D071305-V2
S/N - ###

APPROVALS		DATE	UNLESS OTHERWISE SPECIFIED: DIMENSIONS ARE IN INCHES DECIMAL TOLERANCES: .XX ±.015 .XXX ±.005 ANG TOL: ± 1° SURFACE ROUGHNESS: REMOVE ALL SHARP EDGES. LEAVE .005 X 45° MIN CHAMFER, OR .005 MIN RADIUS.	High Precision Devices 1448 Valtec Lane, Suite C, Boulder, Colorado 80301 Phone: (303) 447-2558 Fax: (303) 447-2548 Web Site: www.hpd-online.com	ORIGINAL DESIGN BY:	MODIFIED BY:
ENGINEERING (HPD): D. Senders		6/15/2007			THIS PRINT & THE EMBEDDED CAD MODEL ARE THE DOCUMENTATION OF RECORD, UNLESS OTHERWISE SPECIFIED. ALL DIMENSIONS IN THE MODEL ARE BASIC, WITH TOLERANCES GIVEN BY: \square .010 A B	LIGO
QUALITY (HPD): C. Danaher		6/15/2007		DESCRIPTION:	Spring Pull-Down, Cap	
MATERIAL: 2024-T351 Al				P/N:	D071305	CONFIG: -
FINISH: None				CAD FILE NAME:	D071305_Spring_Pull-Down-Cap	
MASS: 3.8 lbs				PROJECT:	HAM ISI, Advanced LIGO	
				SIZE	SCALE: 1:2	DRAWN BY: Dave Senders (HPD)
				REV	DATE PRINTED: 4/24/2009	V2

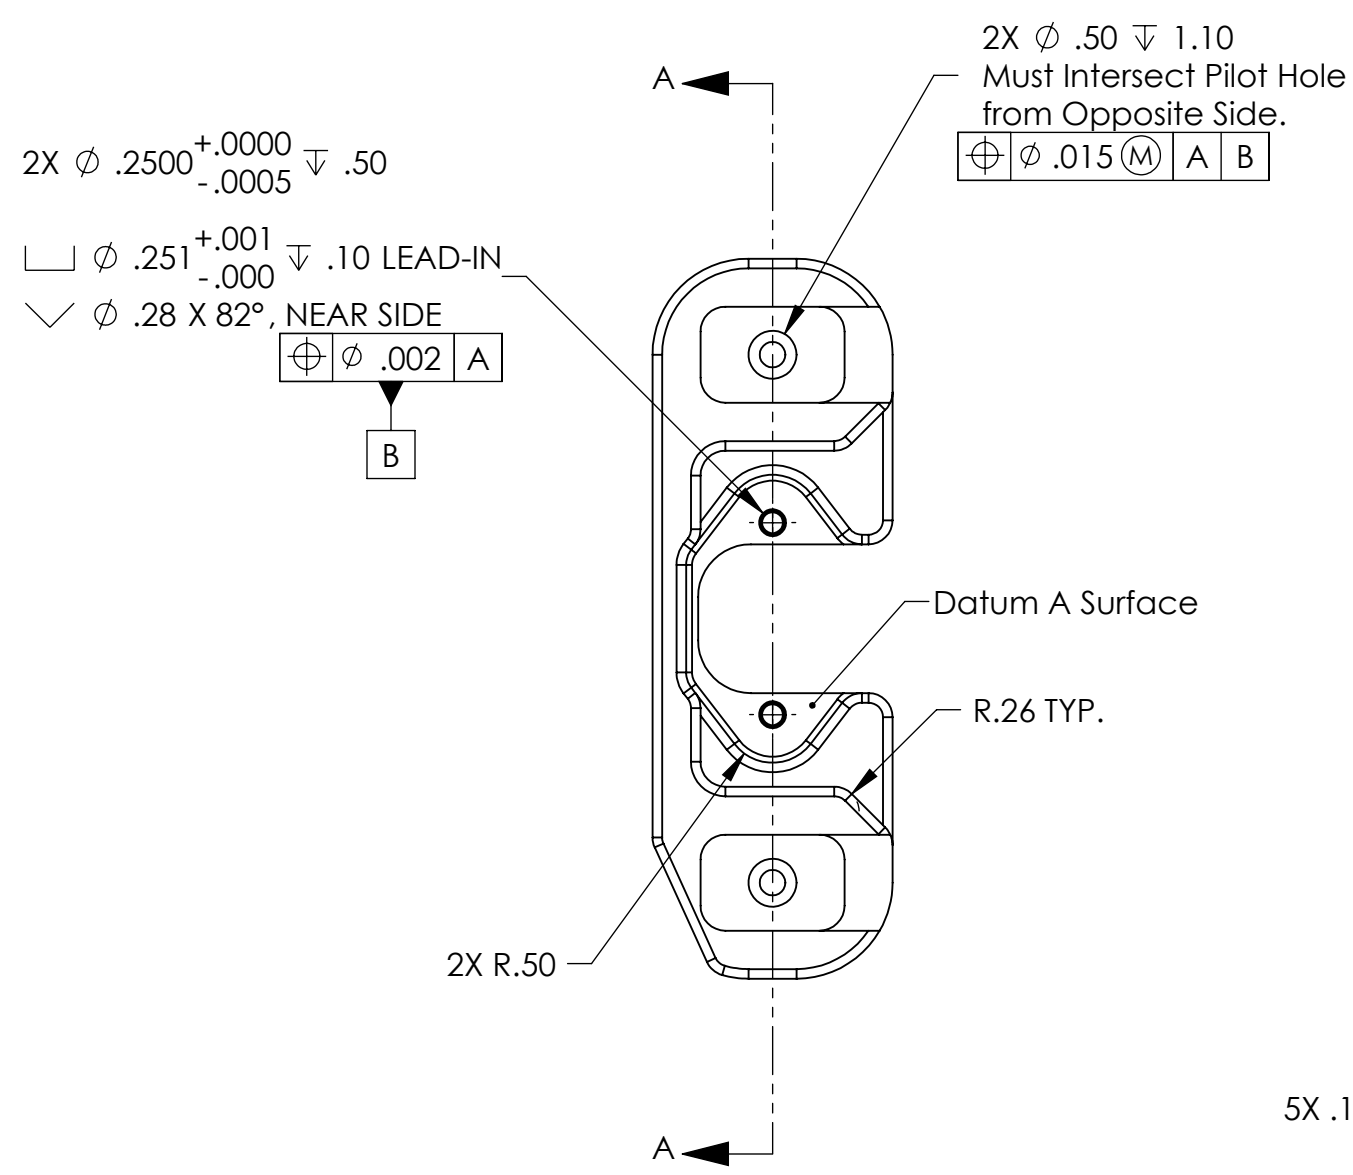
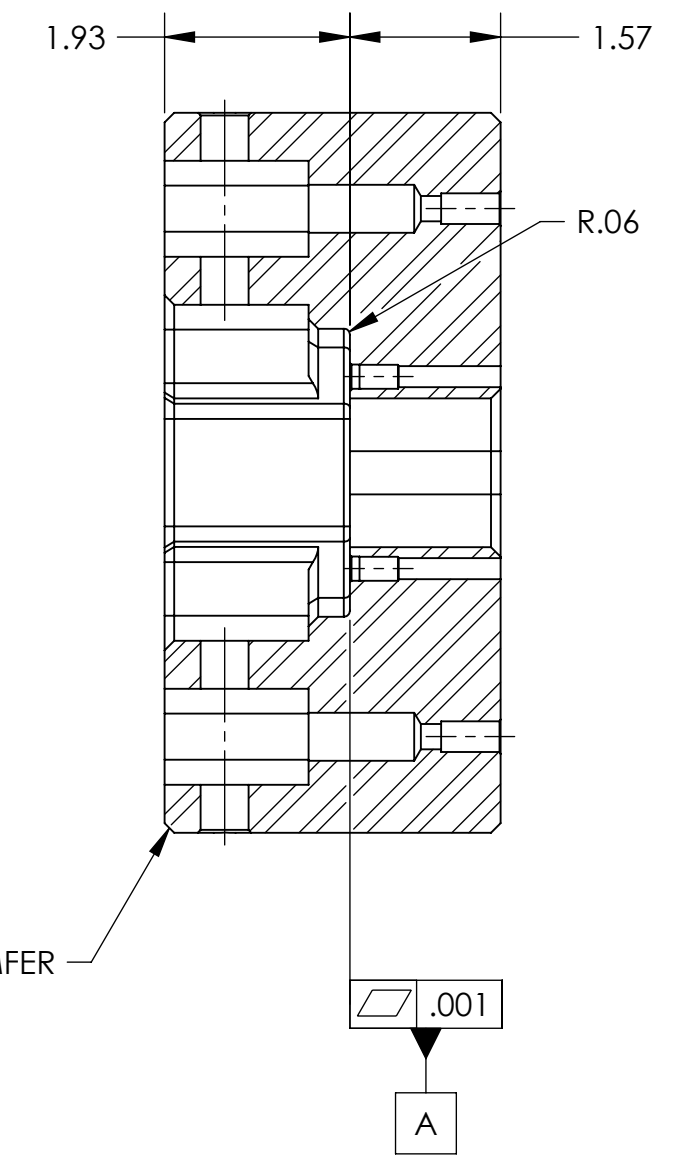
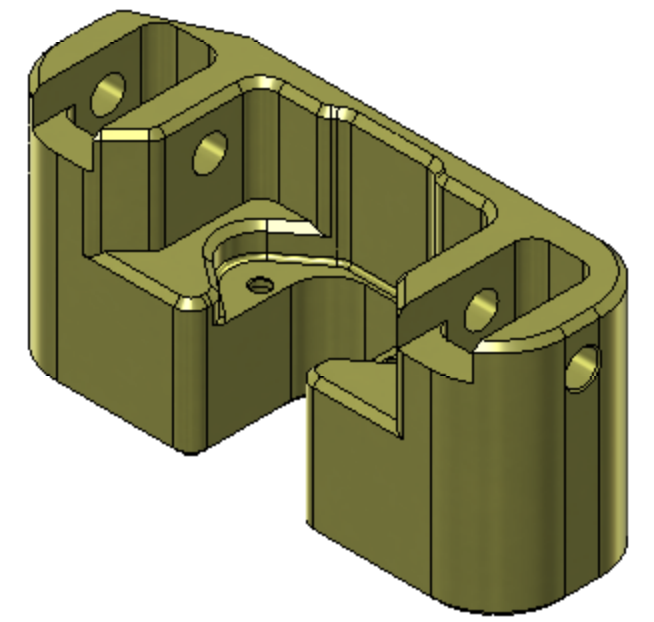
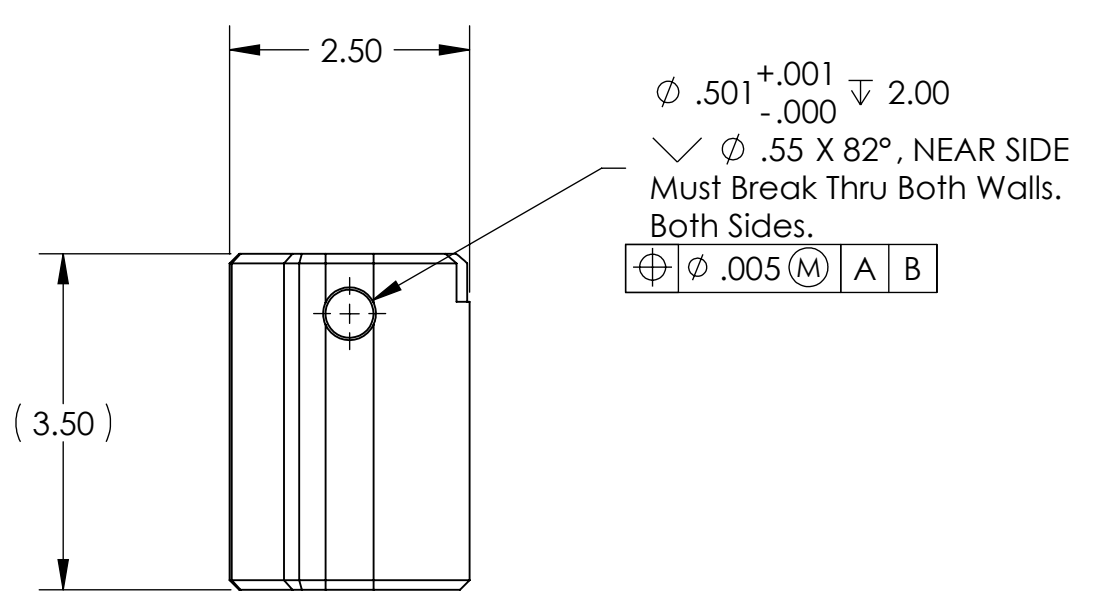
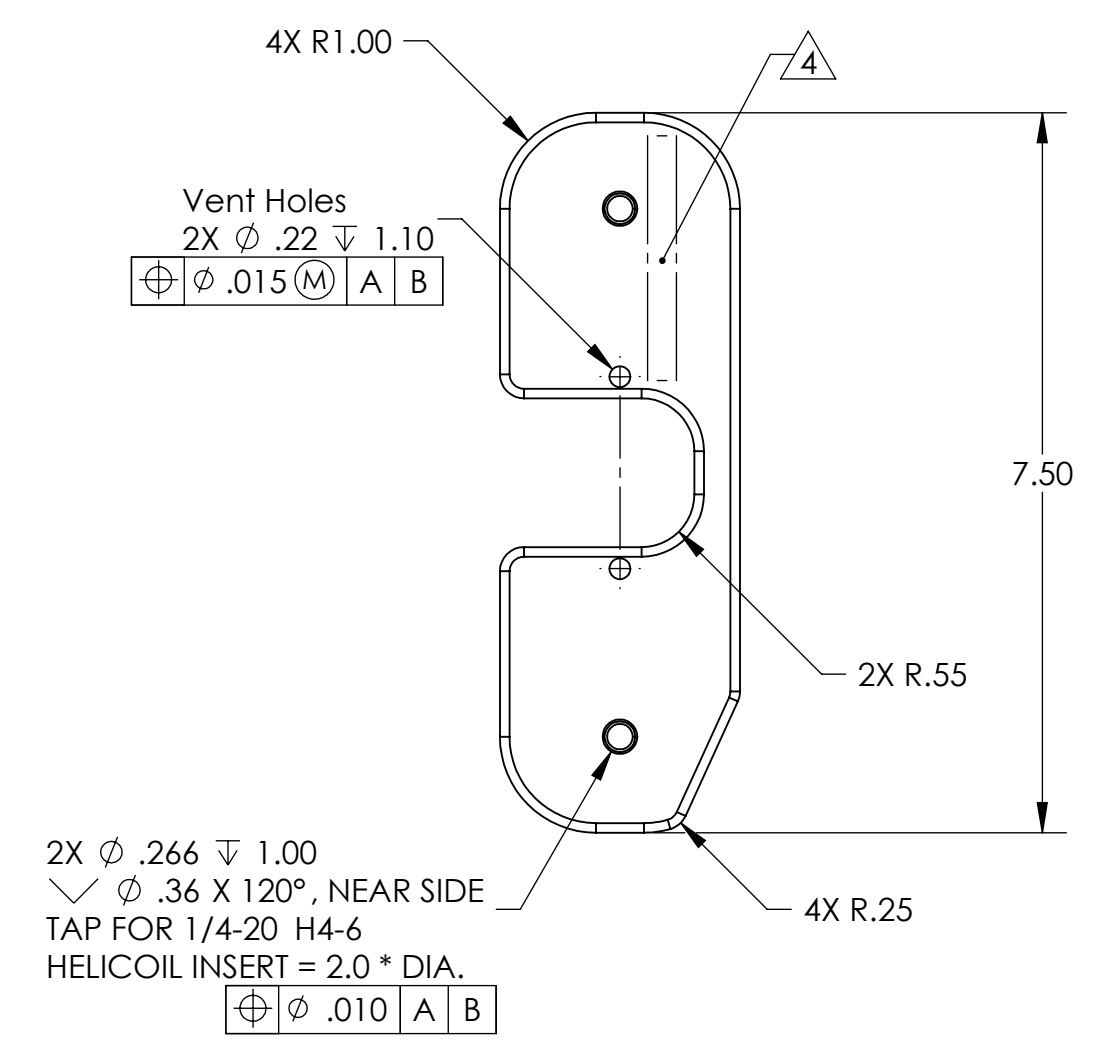
REVISION HISTORY				
REV	DATE	ECO	APPROVAL	DESCRIPTION
V1 / C	31 Jul 2007	1070	D.Senders	Release for Enhanced LIGO.
V2	23 Apr 2009		A. Stein	Release for Advanced LIGO. Increased 2x radius from .50 to .55. Minor changes to vent hole details. Added/modified c'sinks.
